Committee of the Whole Report For the Meeting of October 7, 2021

Subject: Development Permit with Variances Application No. 00179 for 848 Yates

Street

Figure 1: Location of Through-Block Walkway

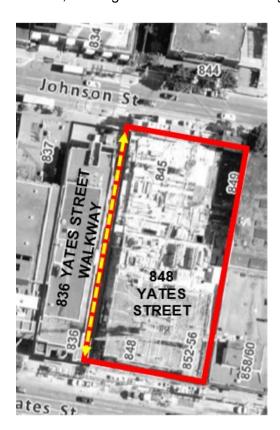
In May 2017, Council approved a Development Permit (DP) for a mixed-use residential building at 848 Yates Street, which included construction of a 1.22 metre walkway on the western edge of the property, secured as a statutory right-of-way (SRW). The SRW would widen the existing through-block walkway on the adjacent property at 836 Yates Street and was intended to integrate two linear sections of a shared midblock walkway connecting Yates and Johnson Streets, running between the two buildings (refer to Figure 1 below).
